Addendum No. 3

Partial Re-Roofing for Mendenhall Middle School
Guilford County Schools
Greensboro, NC
Andre Johnson Architect
Project No.: P1526.00

Date: January 11, 2016

A-106

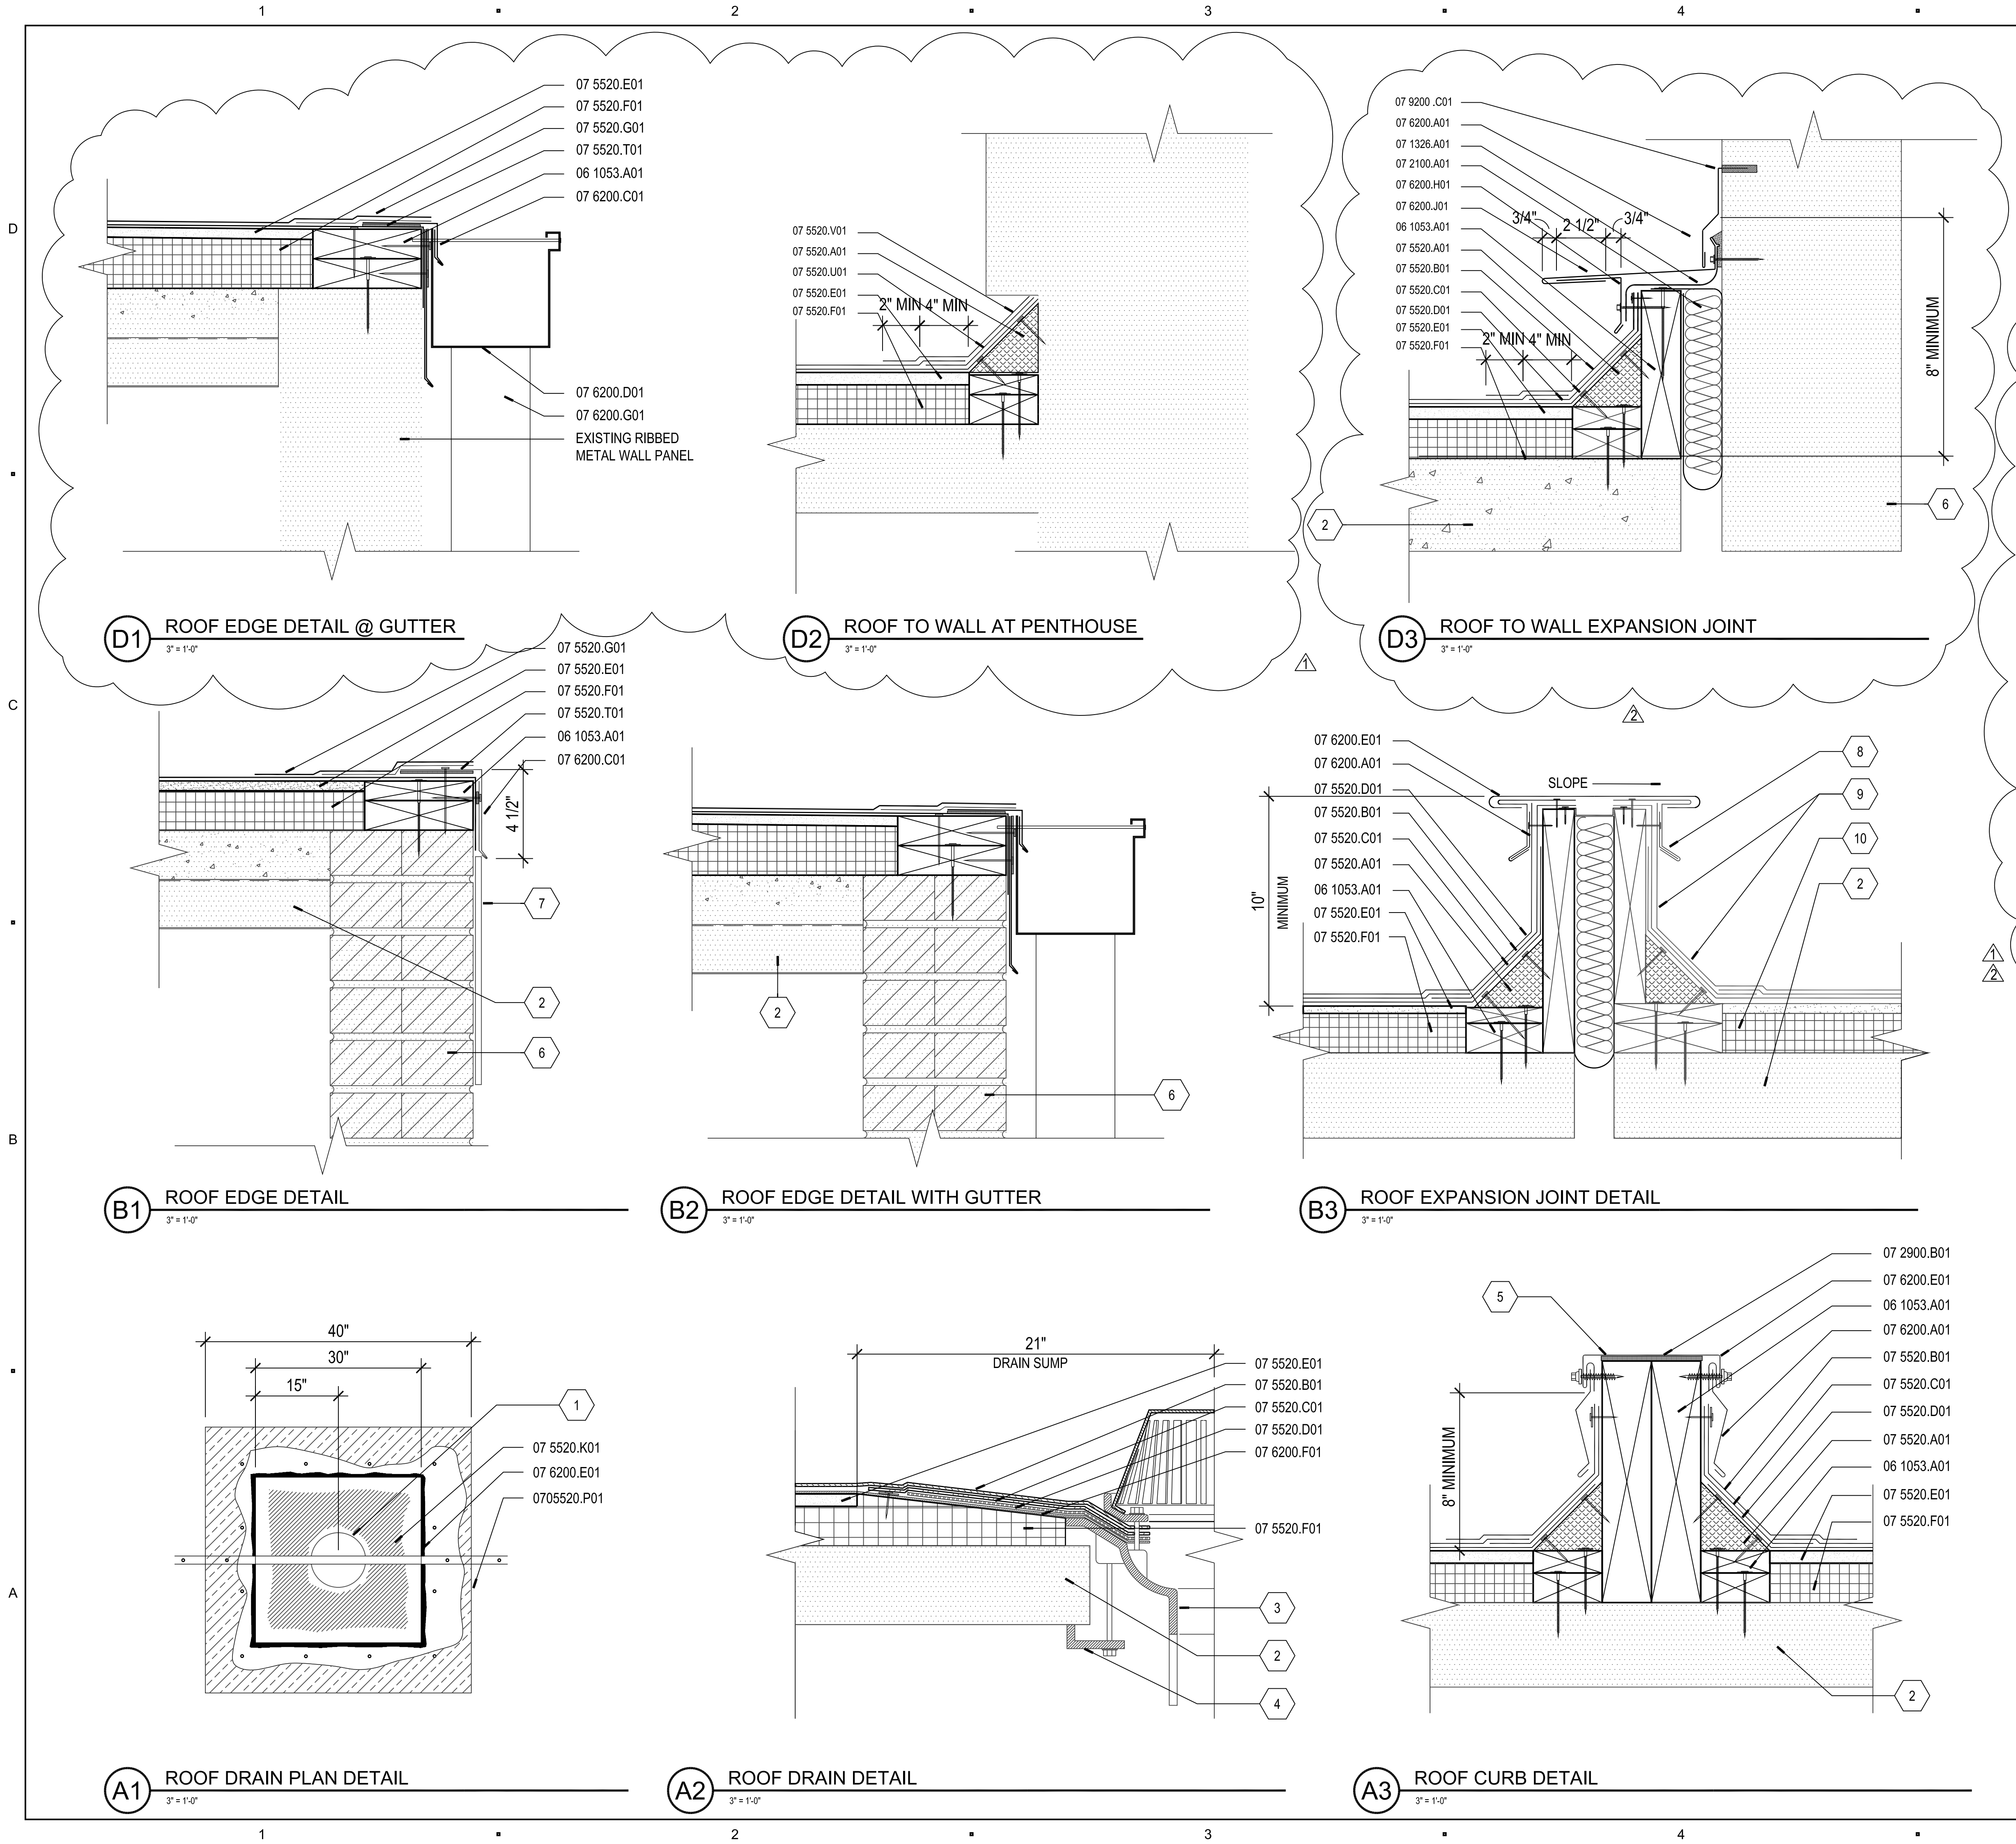
Addendum 3: Item No.11: Sheet A-106

This sheet shall be replaced.
